NUMBER: 19-005-07

GROUP: Steering

DATE: November 13, 2007

**SUBJECT:** Проблема: Скрипит рулевой колонки в районе моторного щита  
Steering Column Dash Seal Squeak/Rubbing Sound

Fig. 1 BLACK MARKING ON WHITE CUP

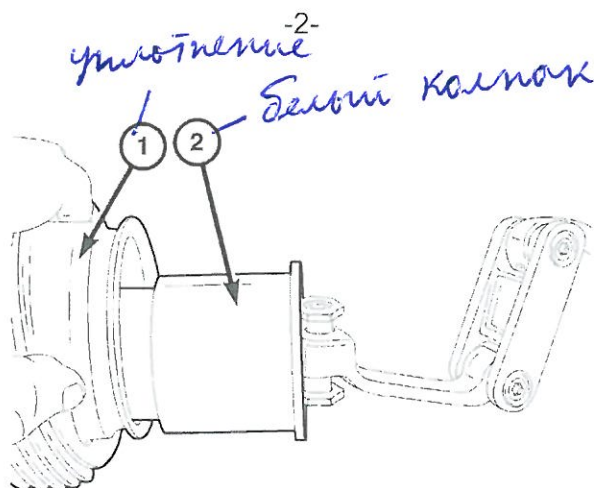
1. Remove the 2 push pins from the lower hush panel below the steering column
2. Remove hush panel to gain access to lower steering column seal
3. Pull the steering column seal down and inspect the white cup the seal rides on.
4. Does the white cup have black markings on white cup in the area shown in (Fig. 1) below?

- a. No >>> Perform Repair Procedure A  
b. Yes >>> Perform Repair Procedure B

1. While the seal is down, clean seal lip and white cup.
2. Apply grease p/n 68028730AA to cup.
